SUNDRY NOTICES AND REPORTS ON WELLS

☒ Oil Well ☐ Gas Well ☐ Other8. Well Name and No.
TODD 14G FEDERAL 7

PROPOSED WELLBORE

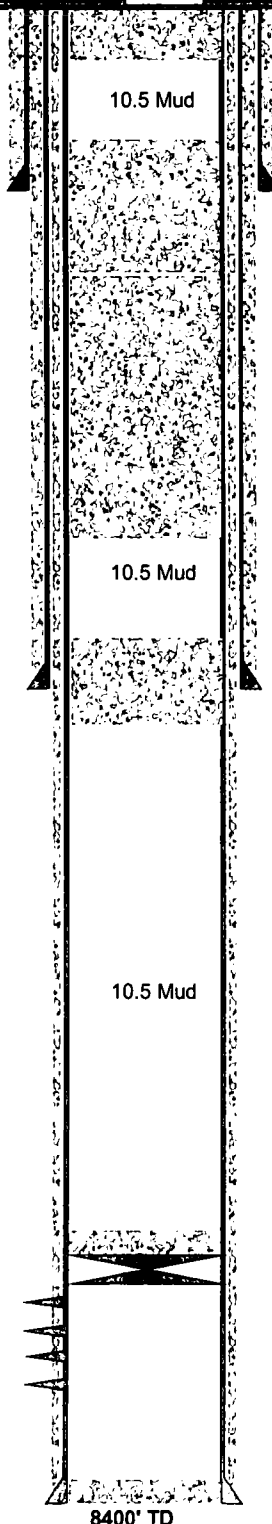
TOC 5 1/2" CS9 UNKNOWN
Run CBL and Report TOC.

GC 9-17-18
Accepted for record - NMOC4278' - 1064' Solid plug
in and out 5 1/2"
CS9. Spot / Perf and
SP2 as CBL Identifies
TOC Behind 5 1/2".
Can cut in stages.

Below ground level dry hole marker required
